Request for Class II Permissive Change(C2PC)

FCC ID: VG8XM262AYY

This is a C2PC application for which the previous grant was issued on 2018-07-16.

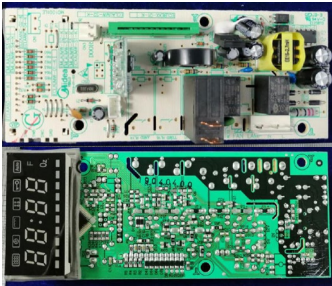
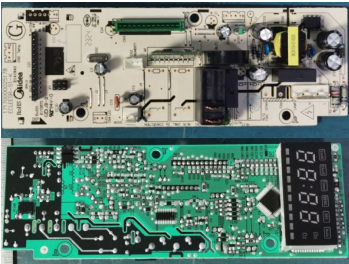
No.:	Original	New	Difference(s)
1			Keypad: Updated front keypad to accommodate child lock function (Child resistant oven door function).
2			Mother board: Modified the peripheral circuit (non-RF circuit) and some individual components and PCB layout. The magnetron and other circuit are exactly same as before.
3	Not Applicable		The new one adds a solenoid valve locking mechanism, the original is not.
